# Access Compliance Report

## Public Rights-of-Way

### (Curb Ramps)

Intersection ID: 48941	Main Street: PEPPERPIKE_WY	Cross Street: MORGAN_LEE_AV	Location: W
ADA ID: 6DC4C16F197A	Ramp Type: Perp	Initial Pass/Fail: Fail	Overall Compliance: No
Severity Score: 22.5			
Codes/Mitigation Info/Possible Solution		Field Measurements/Component Compliance

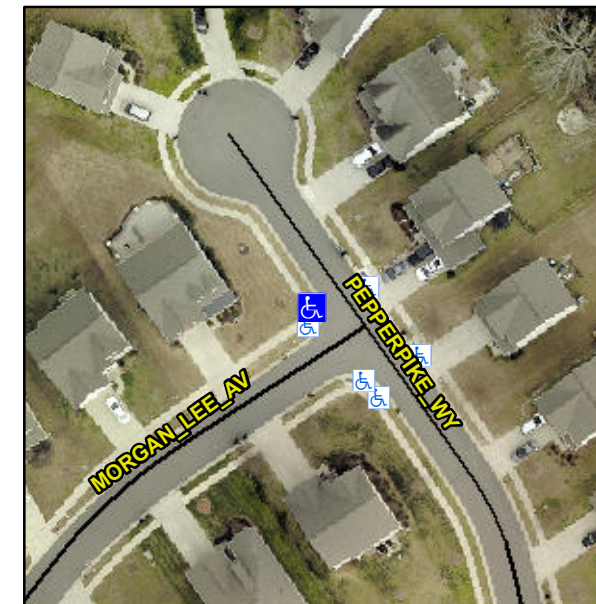
**Not Found, R304.5.1, R304.2.2, R304.5.3**

Compliance	Description	Data	Compliance	Description	Data
N/A	Ramp Length (in)	50.5	No	Ramp Slope (%)	8.5
No	Ramp Width (in)	46.5	No	Ramp XSlope (%)	4.2
N/A	Flare Type LT	N/A	N/A	Flare Type RT	N/A
N/A	Flare Slope LT (%)	N/A	N/A	Flare Slope RT (%)	N/A
N/A	Flare Traversable LT?	N/A	N/A	Flare Traversable RT?	N/A
N/A	Landing Length (in)	N/A	N/A	DWS Provided?	N/A
N/A	Landing Width (in)	N/A	N/A	DWS Contrast?	N/A
N/A	Landing Slope (%)	N/A	N/A	DWS Length (in)	N/A
N/A	Landing X Slope (%)	N/A	N/A	DWS Full Width?	N/A
N/A	Landing Curb? (Y/N)	N/A	N/A	DWS Offset (in)	N/A
N/A	Shared Landing?	N/A			
N/A	Gutter Ponding?	N/A	N/A	Gutter Slope (%)	N/A
N/A	Gutter Lip Ht (in)	N/A	N/A	Gutter X Slope (%)	N/A
N/A	Painted X Walk1?	No	N/A	Painted X Walk2?	N/A
	X Walk 1 Direction	To E		X Walk 2 Direction	N/A
N/A	X Walk 1 Width (in)	N/A	N/A	X Walk 2 Width (in)	N/A
	X Walk 1 Slope (%)	2.8		X Walk 2 Slope (%)	N/A
	X Walk 1 X Slope (%)	1.8		X Walk 2 X Slope (%)	N/A

**Remove & Replace Entire Ramp.**
